From: McLain, Joy [Joy.McLain@tetrattech.com]
Sent: Monday, October 10, 2011 7:36 AM
To: blm@gwcomment.com
Subject: FW: TNC request for additional public comment -- Gateway West
Attachments: Simpson Letter -- Gateway West.pdf

Re: Gateway West Transmission Line – Request for Additional Public Comment

The Snake River Alliance (“Alliance”) appreciates the opportunity to provide comments relating to the Bureau of Land Management’s draft environmental impact statement (DEIS) for the Gateway West Transmission Line Project.

Figure 4. Results of human footprint assessment and alternatives for Section 04.

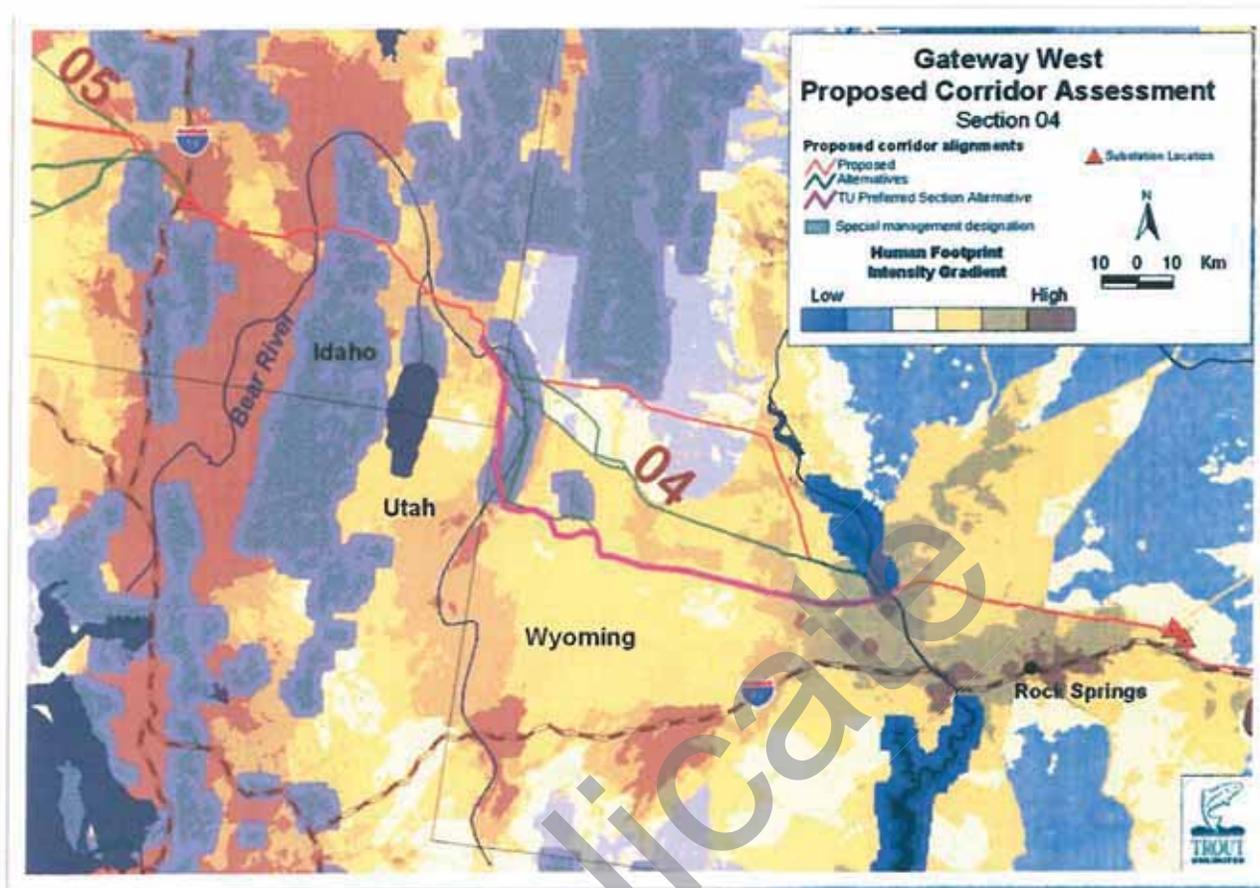
Figure 4 shows the results of the human footprint analysis in conjunction with section 04 of the transmission system. The proposed alternative bisects an area that likely provides moderate to high habitat quality in an area designated as a sage-grouse core area. Although alternative 4B-C, TU's preferred alternative, also crosses the sage-grouse core area, it is associated with lower quality habitat and existing corridors so there will be less additional habitat fragmentation. These southern most alternative sections follow existing corridors, highways and railways. From the juncture of alternative 4B-C, we would then support the alternative section that becomes section 4E which follows Wyoming Highway 30.

We would recommend against alternative 4B-D as it follows the most western Wyoming border route and intersecting portions of the Cokeville Meadows National Wildlife Refuge. The Refuge supports one of the highest densities of nesting waterfowl habitat in Wyoming, has potential for the reintroduction of trumpeter swans, and provides significant and important habitat for greater sage grouse, mule deer, elk and pronghorn. In addition, TU has several Bonneville cutthroat trout habitat restoration projects established near the Refuge boundaries and numerous drainages within the Refuge.

Figure 5. Results of human footprint assessment and alternatives for Section 07, 08, 09, and 10.

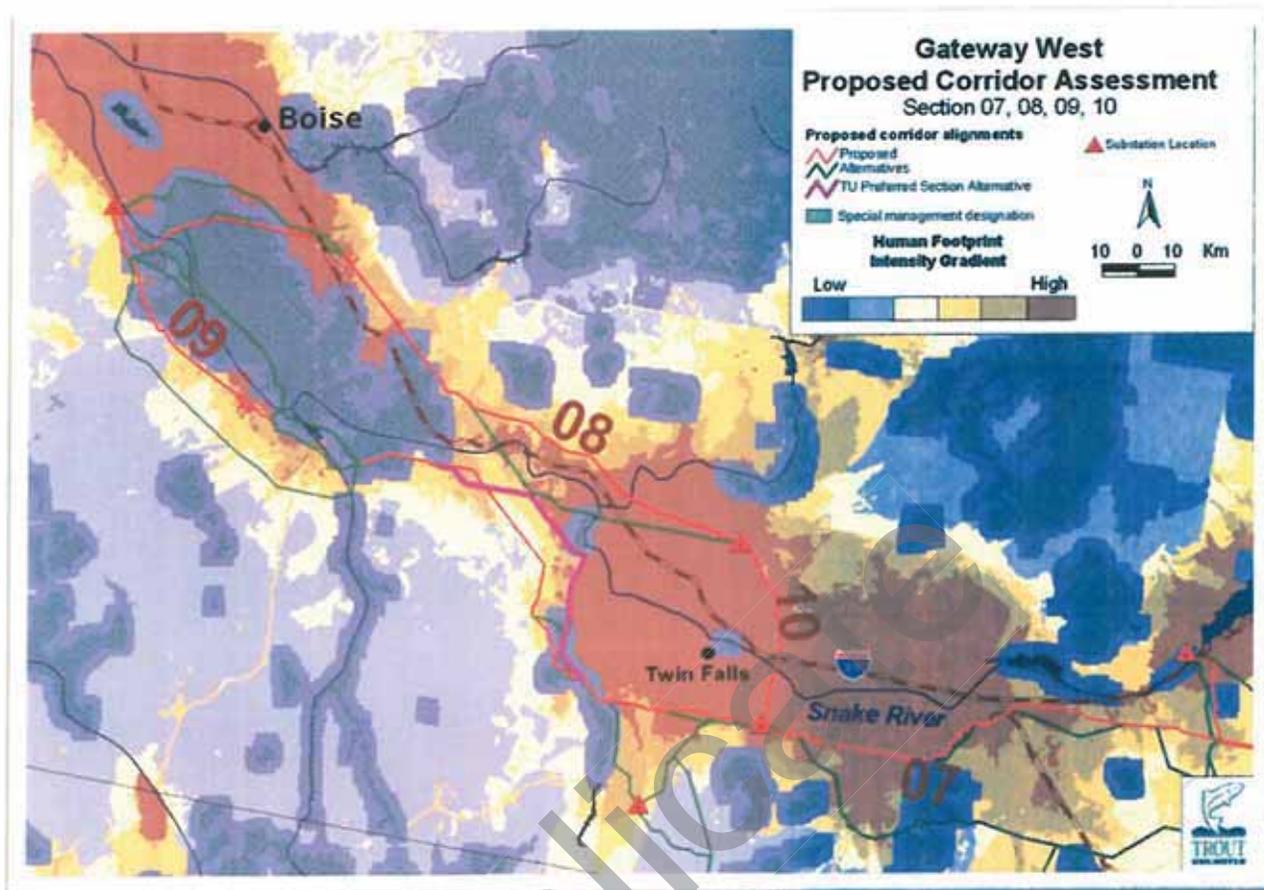
Figure 5 shows the alternative alignments for sections 07, 08, 09, and 10. In general, TU's preferred alternative is associated with degraded and converted lands so additional habitat fragmentation is less of a concern. Stream crossings or any construction within or adjacent to the riparian area will require site specific analyses to minimize impacts to aquatic resources. Section 09 crosses a number of special management areas including the Snake River Birds of Prey Area and the Salmon Falls Creek Wild and Scenic River. In order to minimize impacts to these important resources we recommend the use of existing transmission corridors and rights-of-way whenever possible. We also prefer stronger buffer setbacks to minimize the potential for soil erosion and damaging sedimentation to important native trout habitat. For this reason, we prefer alternative 9B for section 09 since it parallels an existing transmission line and avoids crossing Salmon Falls Creek in either the eligible or designated wild and scenic river sections.

Figure 6. Native trout populations in Western Wyoming which may be potentially impacted by the Gateway West transmission project.

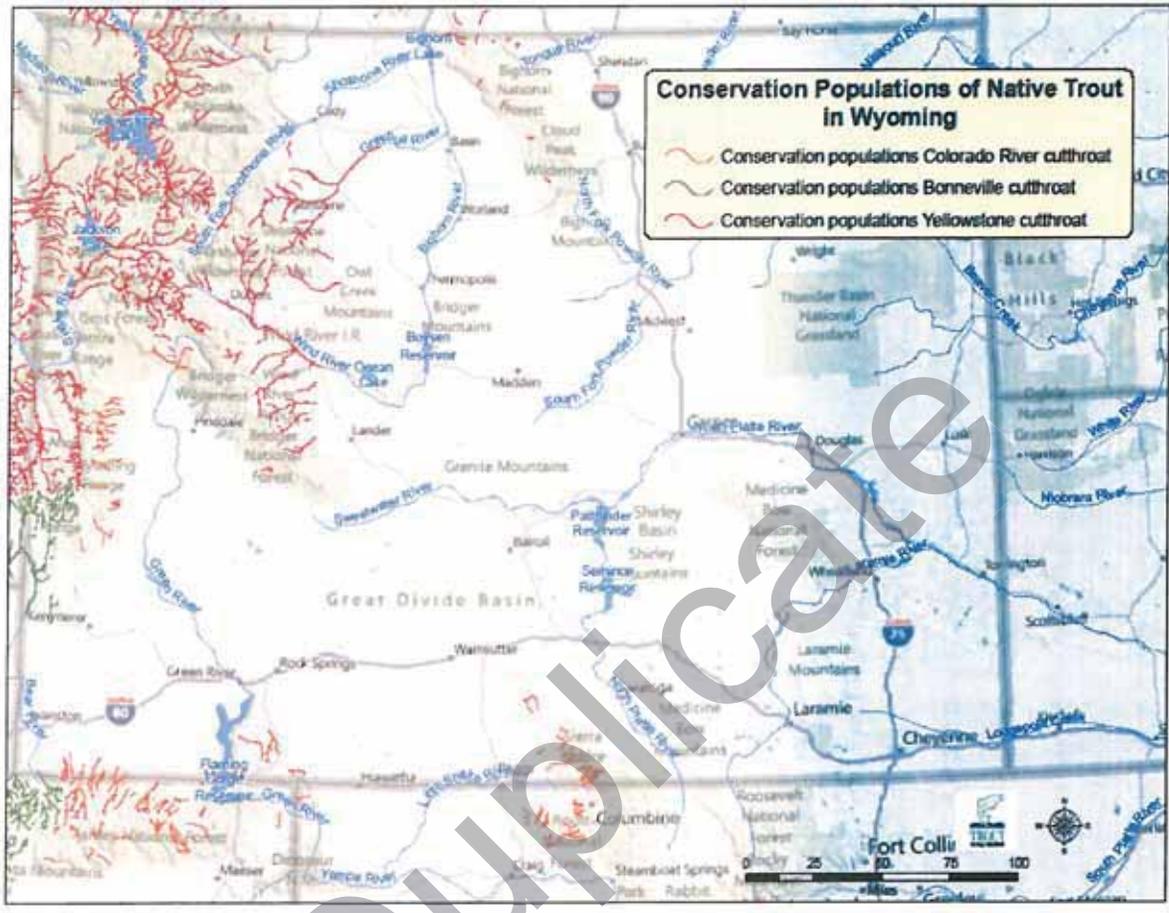
improvement efforts. As illustrated in Figures 6 and 7, native trout habitat exists in several areas in Wyoming and Idaho along the transmission route and it is our desire to maintain the integrity of these important ecological resources.

Figure 7. Native trout populations in Eastern Idaho which may be potentially impacted by the Gateway West transmission project.

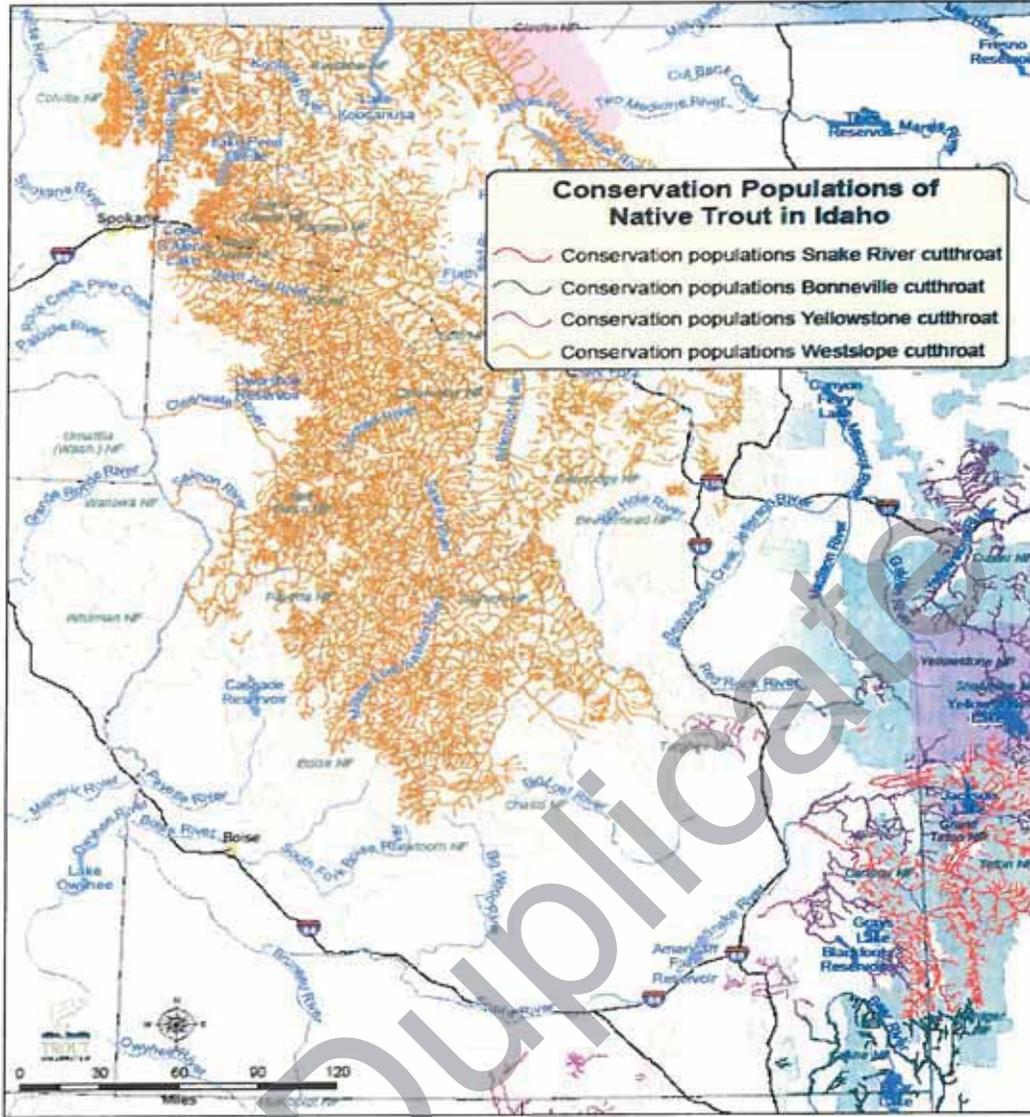
Westslope cutthroat (WCT) populations include habitat areas in Idaho and has been identified in the DEIS as a cutthroat species occurring within the project boundaries. However, the BLM may want to reassess this statement as most of the science and agency data shows its habitat range as further north (see Figure 7) from the proposed transmission corridor.

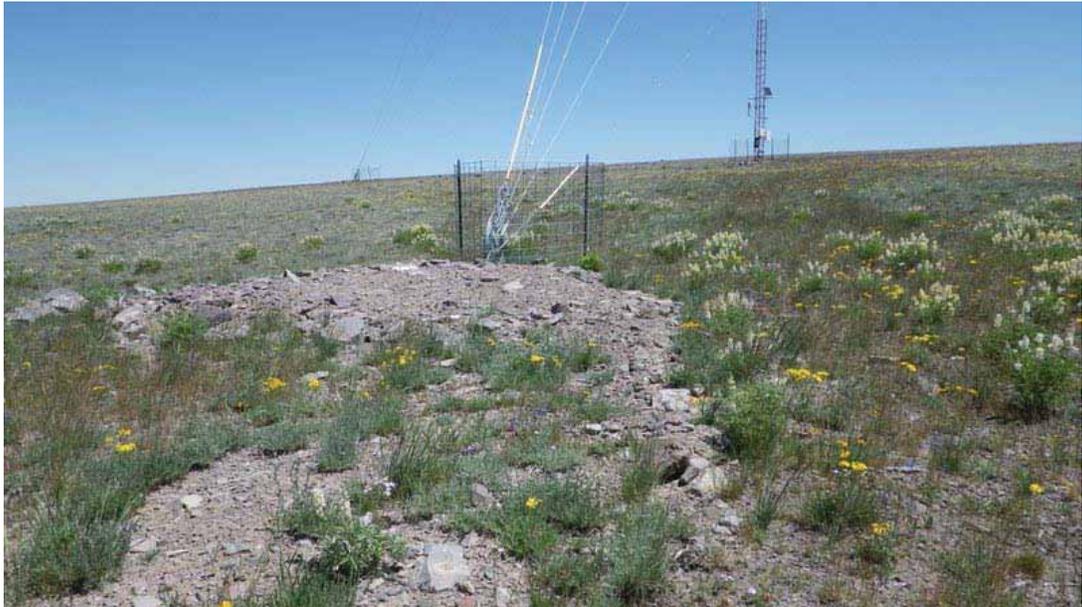
See Photo of MET disturbance - just mooring the MET towers required blasting, as described in the 2008 MET Tower EA.

Now weeds like tumbled mustard and cheatgrass are invading sites – like at this Nevada MET tower ¹⁰⁰²⁵⁵ pictured.

Figure 1.4 from Strickland et al. (2011); note the disproportionately large influence of the two rightmost observations on the regression slope (if only one of these points is removed, the line becomes either much steeper or much less steep).

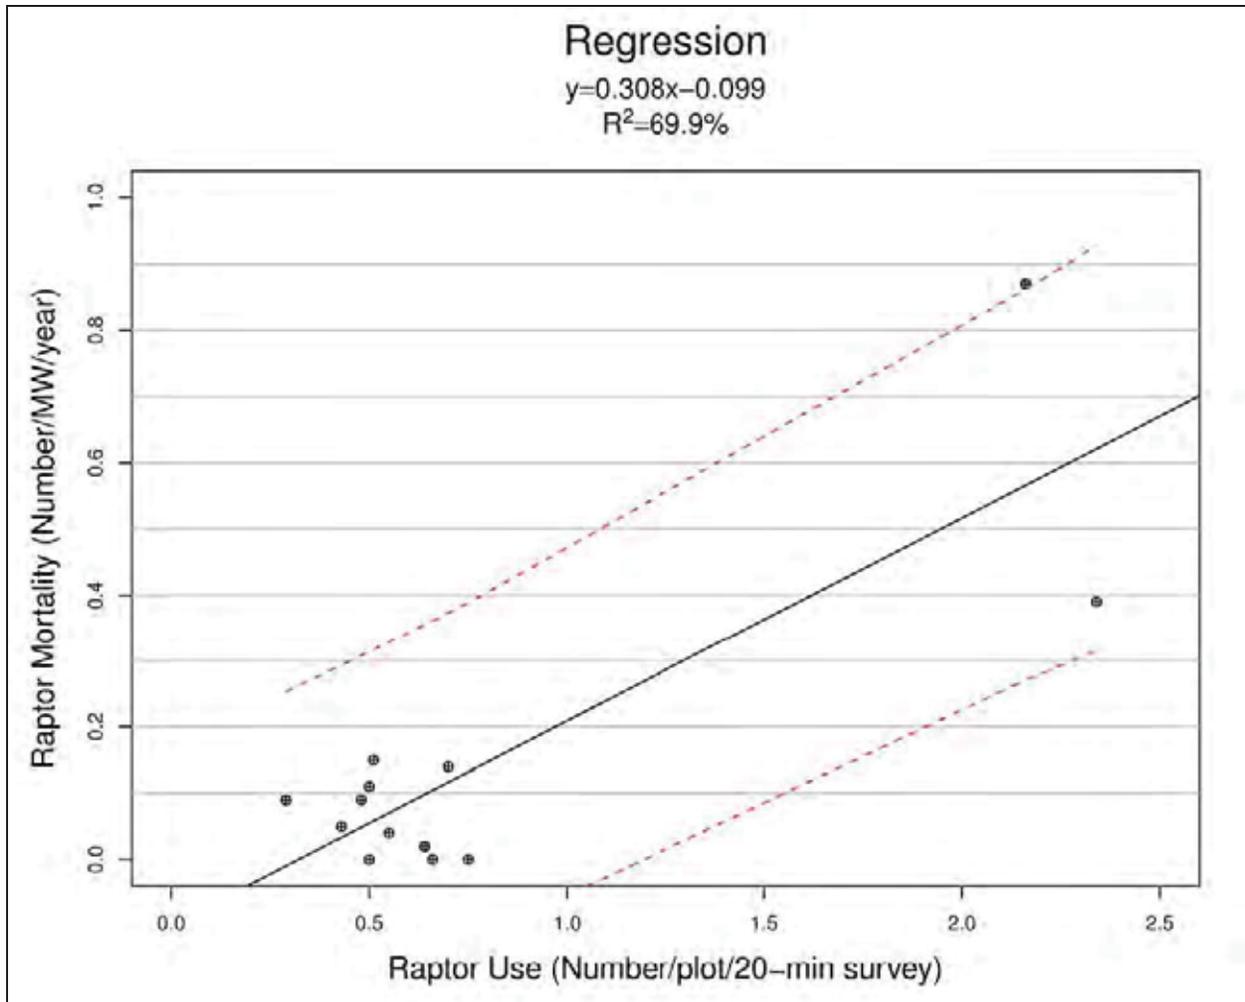
Additionally, we are not confident in WEST's annual raptor and eagle mortality estimates, due to flaws that have been pointed out repeatedly by others in previous reviews of their fatality estimation technique (e.g., wind mortality expert Kevin Smallwood). Most importantly, in their treatment of the mortality estimation (see 4.14-18 and 4.14-19), they base their estimate on a regression relationship between pre-project raptor use and observed post-project mortality gleaned from data reported at a number of modern wind facilities (but excluding more modern turbines/data from Altamont). In previous assessments, WEST has included a figure of this relationship, but it is not included in the current DEIS. However, the figure of the regression provided below was taken from Stickland et al. (2011; primary authorship by WEST consultants) shows the major flaw with this equation: namely, two points at the far right are the primary drivers behind the slope of the regression line and if different results had been observed for even one of these sites, the slope of the relationship could have been altered significantly. The bottom line is that this supposedly strong regression (69.9% R-squared value) cannot be relied upon to predict fatality, as has been repeatedly pointed out by K. Smallwood elsewhere.
